# CITY OF ALBUQUERQUE

**Re:    Mountain Mahogany Community School PH II, 5014 4<sup>th</sup> St NW,  
Request for Permanent C.O. –Accepted  
Engineer's Stamp dated: 03-01-12, (F14/D062)  
Certification dated: 07-12-12**

**Re: Mountain Mahogany Community School, 5014 4<sup>th</sup> Street NW**  
**Grading and Drainage Plan**  
**Engineer's Stamp date 3-01-12 (F14/D062)**

**Re: Mountain Mahogany Community School, 5014 4<sup>th</sup> Street NW, Grading and Drainage Plan**

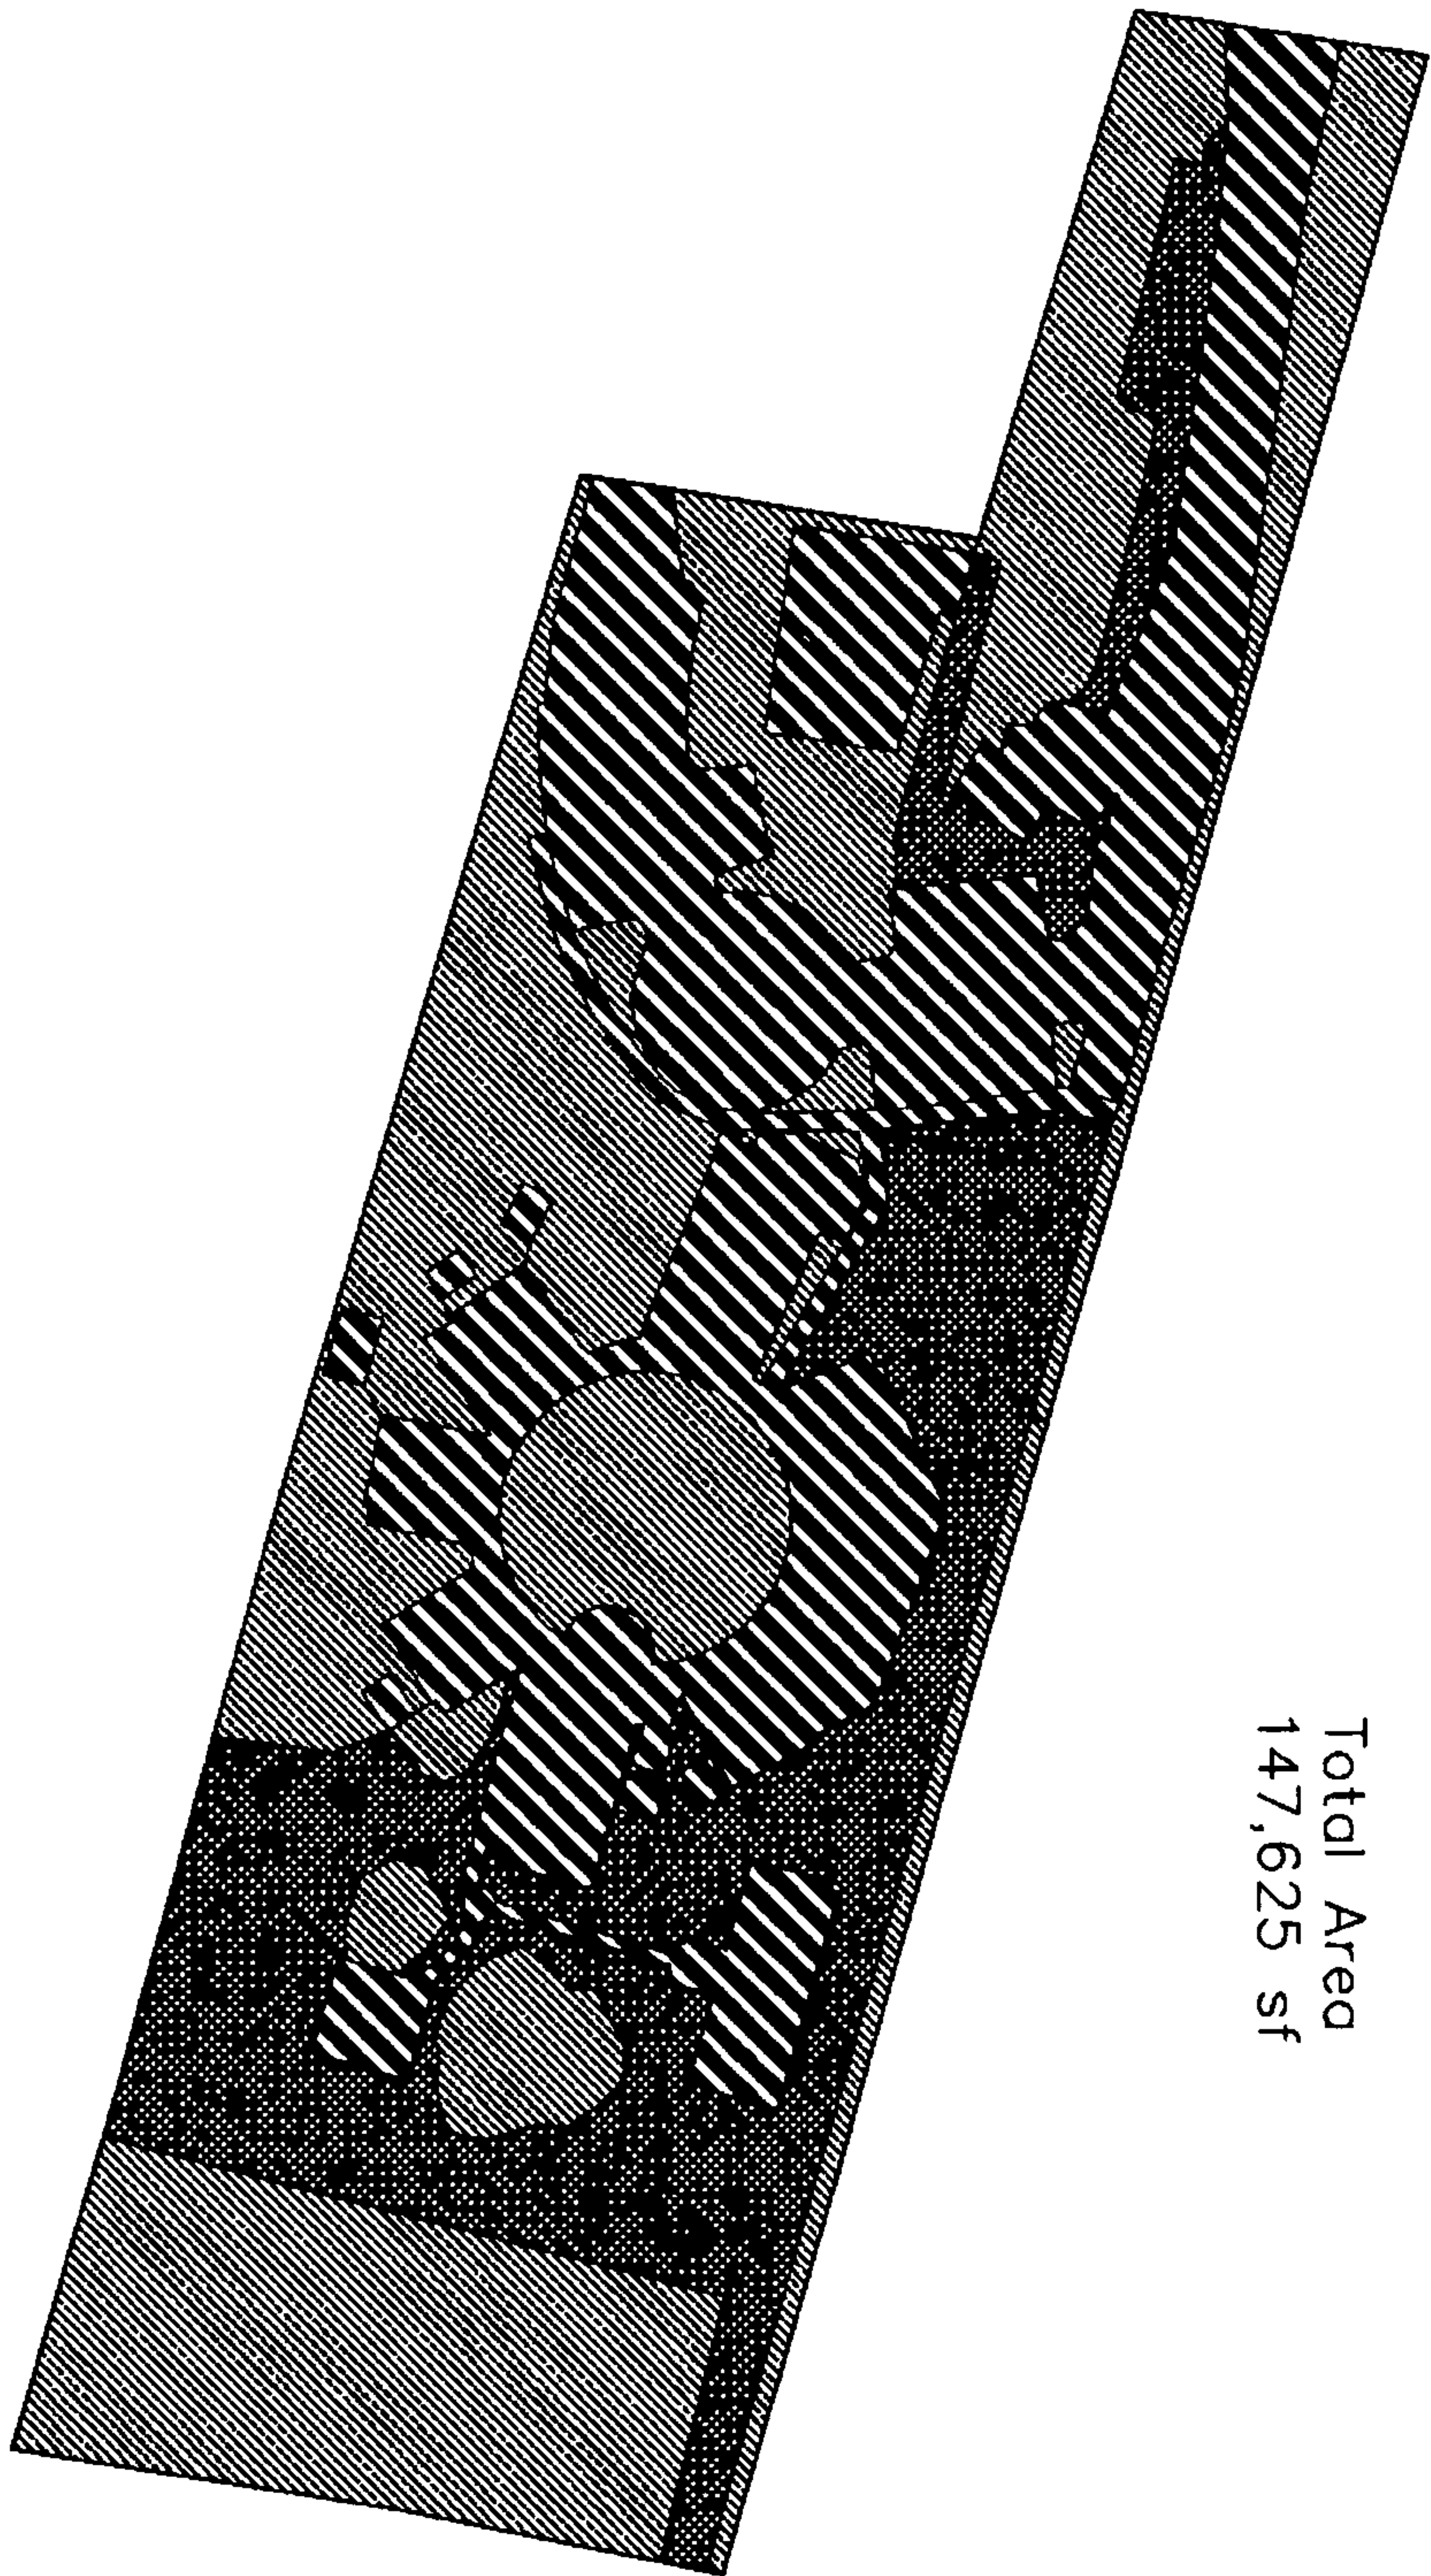
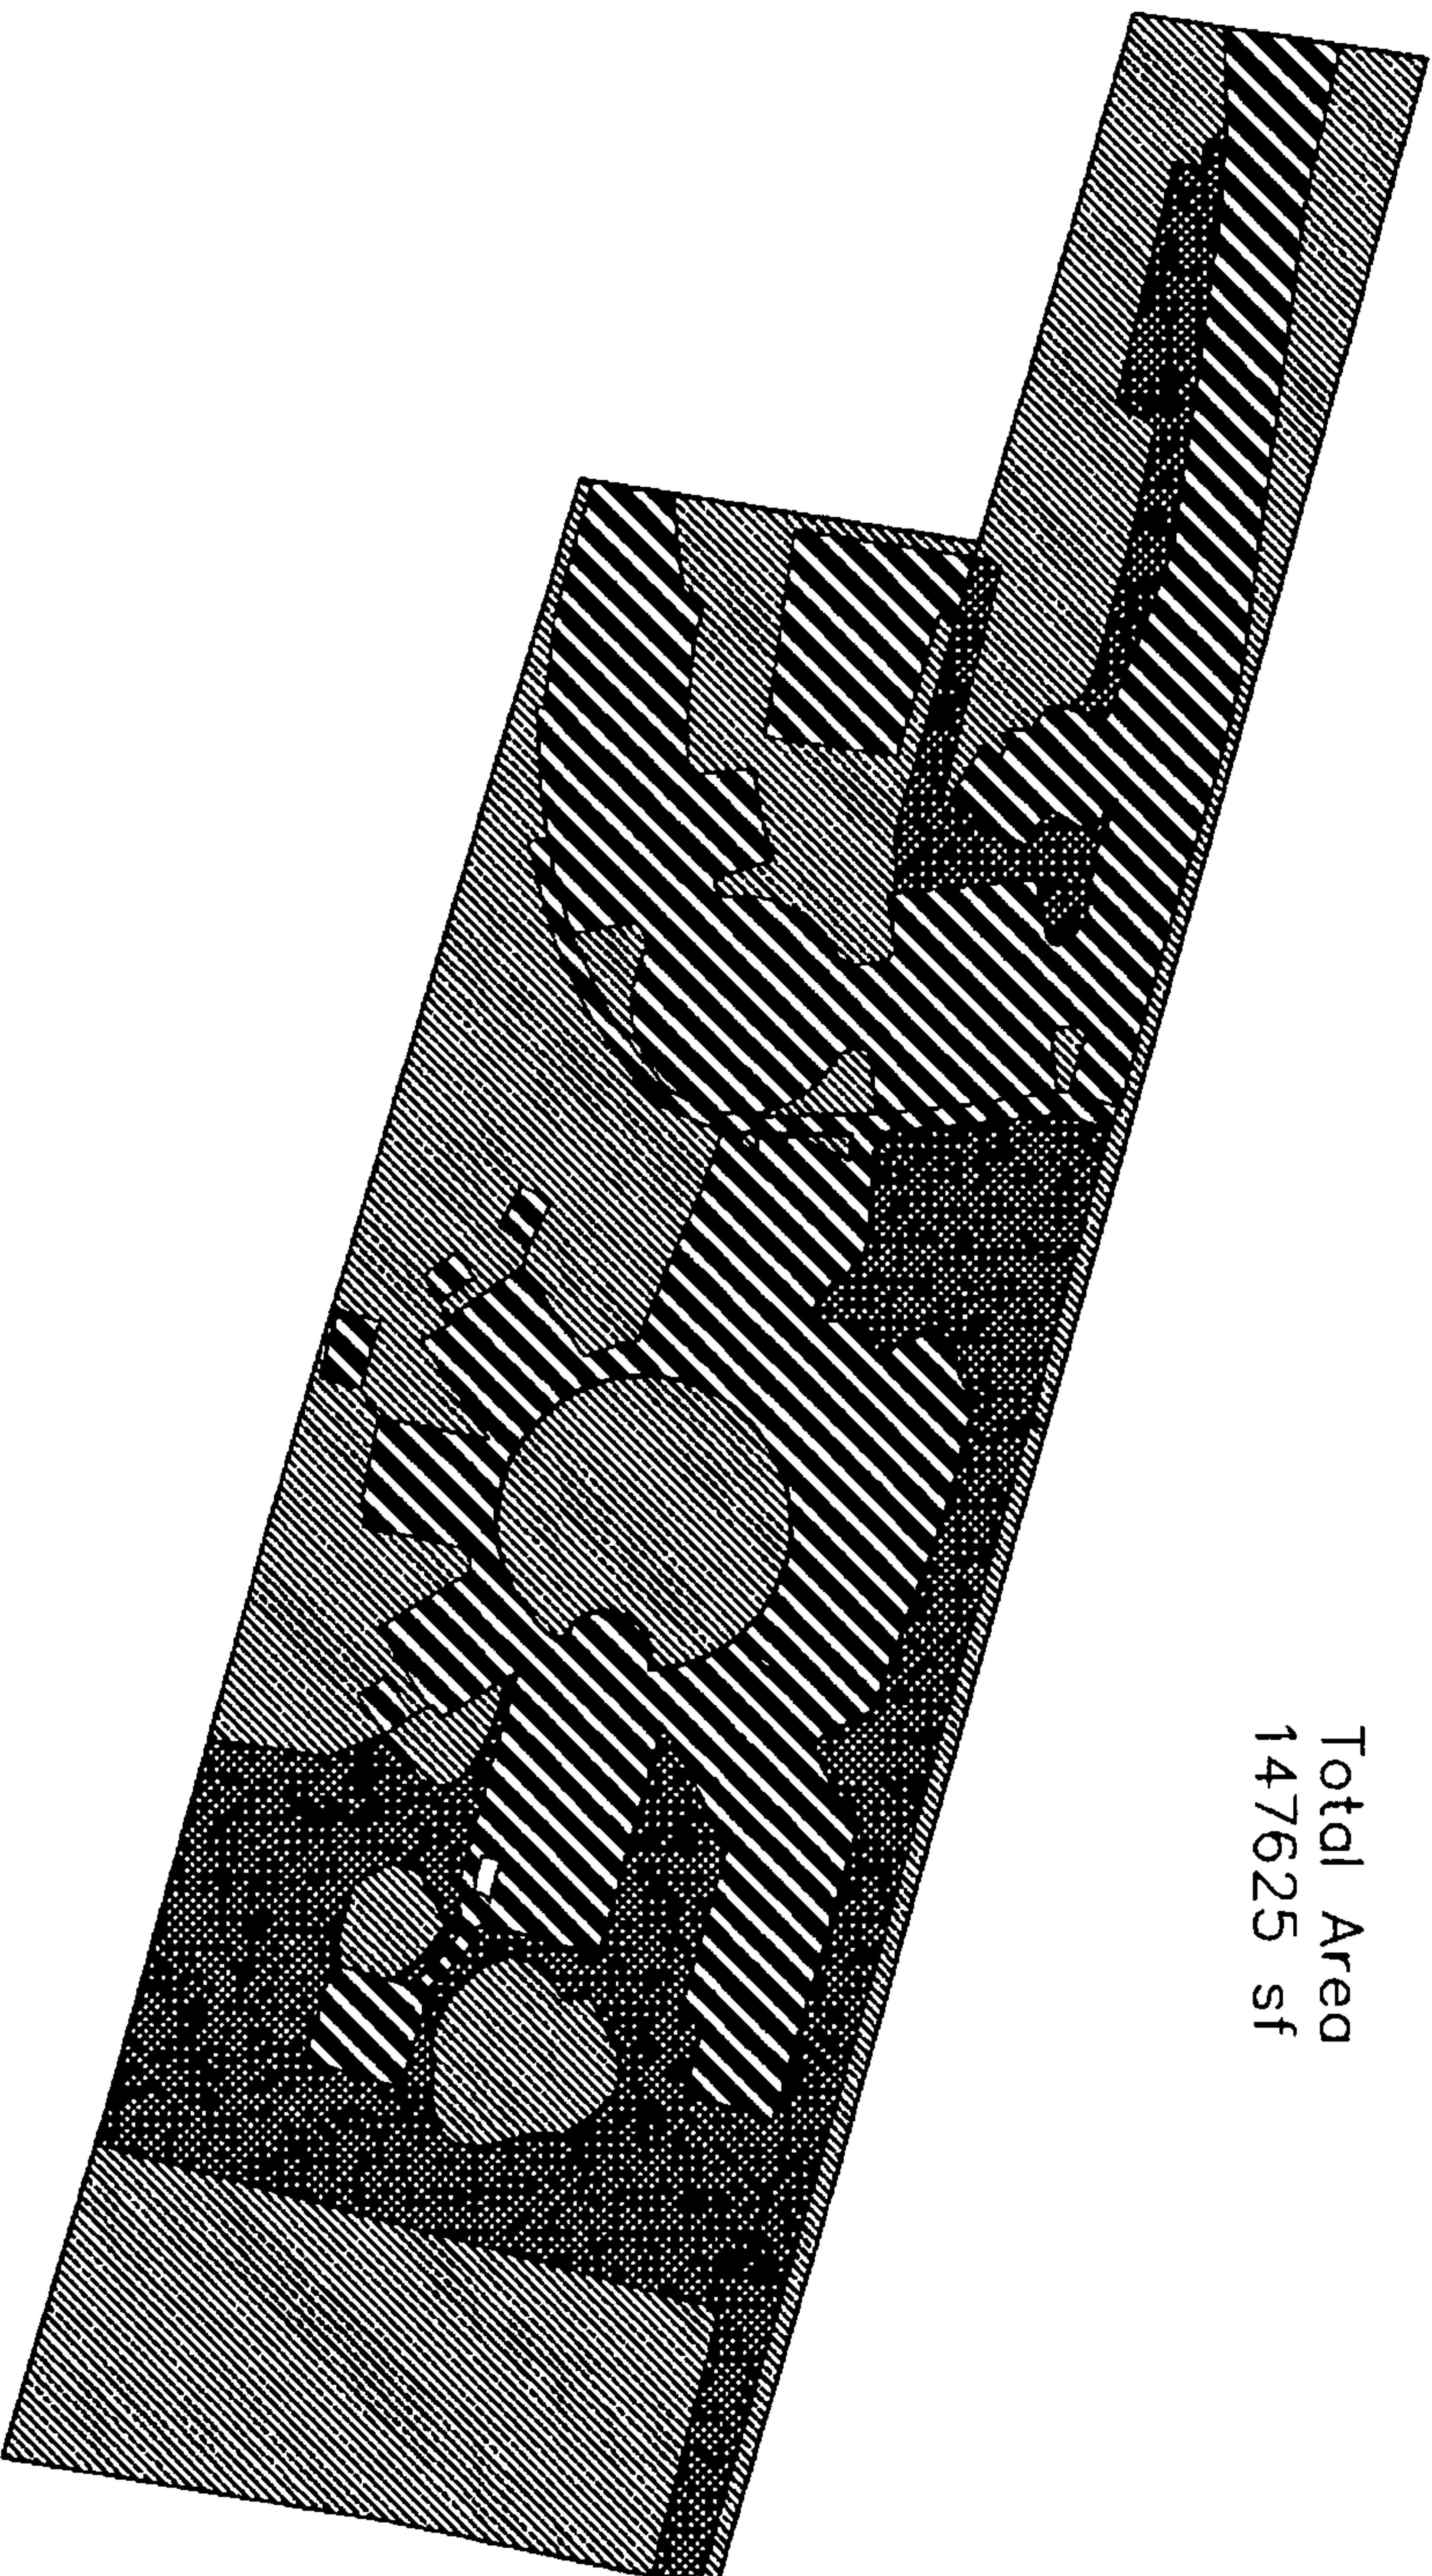
- An approved Grading and Drainage plan is on file for this property and the proposed grading appears to impact the on-site retention ponds that were approved to contain the 100 yr, 10 day storm event.
- One of the existing structures was previously built without a permit and encroaches on one of the approved retention ponds.
- The proposed structures also appear to encroach on another on-site retention pond.
- Provide pond volume calculations to ensure proper water retention is maintained.

1. A pond volume analysis is included in the supplemental information to address the proposed construction as well as to provide for some additional future improvements.
2. We have called for the installation of six percolation pits within the various ponds to assist with draining the ponds. There is a shallow clay lens (within the upper 4 feet).

In order to generate the volumes required for each of the conditions, land treatment areas were calculated (see Land Treatment Maps) and the resulting percentages were entered into the DPM calculations to obtain the volume generated for the 100-year 6-hour storm event. The 100-year 10-day volume was then calculated per the DPM to determine the required ponding volume.
